Docket Item # 4
BAR CASE #2010-0118

BAR Meeting
June 16, 2010

ISSUE: Alterations
APPLICANT: Old Town Windows and Doors for Joseph Costa
LOCATION: 610 South Columbus Street
ZONE: CD/Commercial

Figure 5: Specification sheet for proposed replacement windows

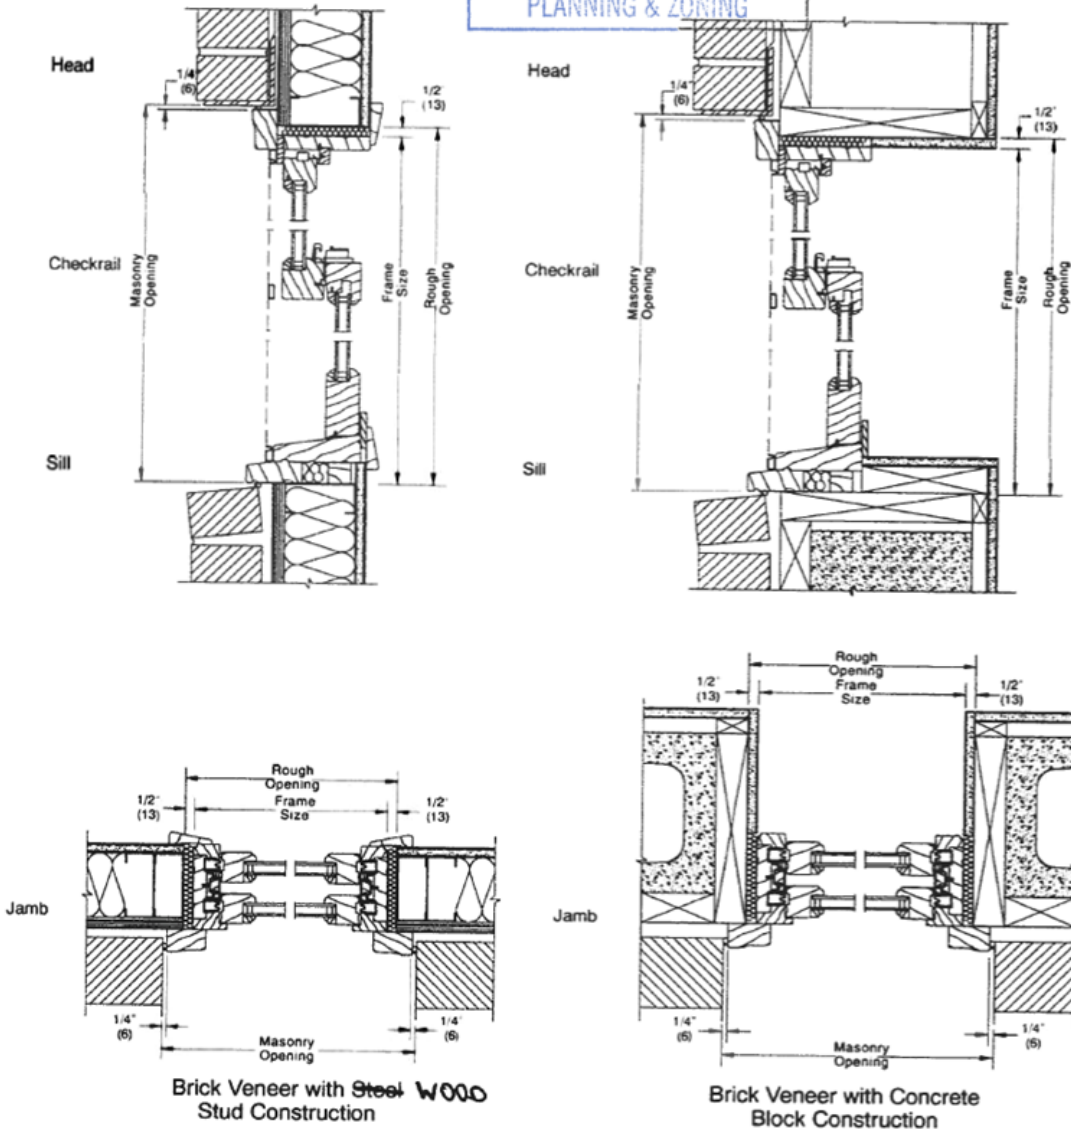
The *Design Guidelines* recommend that: "...replacement windows should be appropriate to the historic period of the architectural style of the building". The *Guidelines* state that single-glazed, true divided light windows with interior storm sash are the preferred replacement window type. The *Guidelines* continue by saying other acceptable window types are "double-glazed true divided light wood windows..." In this particular case, double-glazed windows, which were commercially available when this townhouse was constructed in 1979, are appropriate replacement windows and significantly more attractive than the existing single glazed windows covered by aluminum storm panels. Staff further believes that the appearance of modern simulated divided light windows is indistinguishable from true divided light sash and allows the profile of the muntins to be thinner and more historically accurate.

Therefore, given the age of the townhouse and the fact that the existing 6/6 light pattern and putty glazed muntin profile and size will be retained, Staff does not object to the installation of painted wood double-insulated windows and doors, with simulated divided lights, and dark colored interior spacer bars. Staff finds the proposed replacement windows appropriate and compatible with nearby buildings of historic merit.

Staff recommends approval of the application as submitted.
